Access Compliance Report

Public Rights-of-Way

(Curb Ramps)

Intersection ID: 2684	Main Street: CARDINAL_POINT_RD	Cross Street: SUMMERGOLD_WY	Location: SW
ADA ID: DA1AFDA13308	Ramp Type: BlendTrans1	Initial Pass/Fail: Pass	Overall Compliance: No
		Severity Score: 0

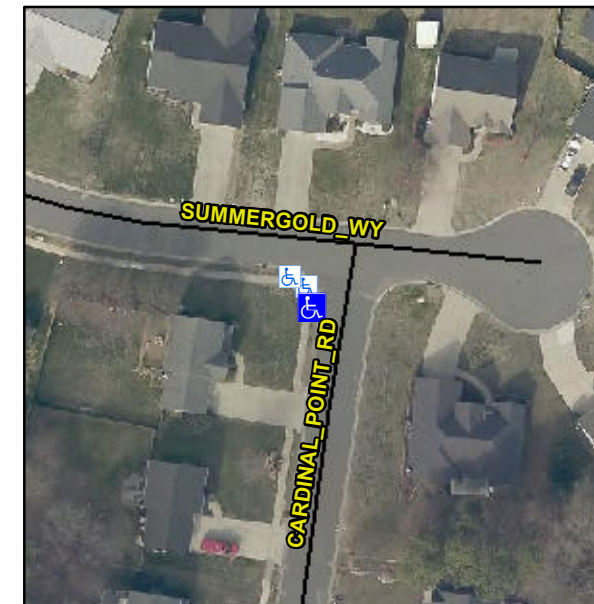
Not Found, R304.2.2-Perp, R304.3.2-Para, R305.2

Compliance	Description	Data	Compliance	Description	Data
N/A	Ramp Length (in)	49.5	Yes	BlendTrans Slope (%)	3.2
Yes	Ramp Width (in)	48.0	Yes	BlendTrans XSlope (%)	0.3
N/A	Flare Type LT	Sloped	N/A	Flare Type RT	Sloped
N/A	Flare Slope LT (%)	4.8	N/A	Flare Slope RT (%)	1.4
N/A	Flare Traversable LT?	No	N/A	Flare Traversable RT?	No
Yes	Landing Length (in)	48.0	Yes	DWS Provided?	Yes
Yes	Landing Width (in)	48.0	Yes	DWS Contrast?	Yes
No	Landing Slope (%)	4.2	Yes	DWS Length (in)	25.5
Yes	Landing X Slope (%)	0.2	Yes	DWS Full Width?	Yes
N/A	Landing Curb? (Y/N)	No	No	DWS Offset (in)	3.0
N/A	Shared Landing?	No			
Yes	Gutter Ponding?	No	Yes	Gutter Slope (%)	2.4
Yes	Gutter Lip Ht (in)	0.0	Yes	Gutter X Slope (%)	1.0
N/A	Painted X Walk1?	No	N/A	Painted X Walk2?	N/A
	X Walk 1 Direction	To E		X Walk 2 Direction	N/A
	X Walk 1 Width (in)	N/A		X Walk 2 Width (in)	N/A
	X Walk 1 Slope (%)	1.2		X Walk 2 Slope (%)	N/A
	X Walk 1 X Slope (%)	1.2		X Walk 2 X Slope (%)	N/A

N/A	Ramp inside XWalk1?	N/A	N/A	Ramp inside XWalk2?	N/A
	Road Slope (%)	1.2		Clear Space?	Yes
	Road X Slope (%)	1.2	N/A	Clear Space to XWalk (in)	N/A
Yes	Any Obstructions?	No	Yes	Storm Grate/Utility Hazard?	No
	Obstruction Type			Storm Grate/Utility Type	
			N/A		N/A
			Yes	Surface Condition? (G/P)	Good
			No	Curb Slope (%)	8.6

Remove & Replace Curb Ramp With Two New Directional Ramps or Equivalent.
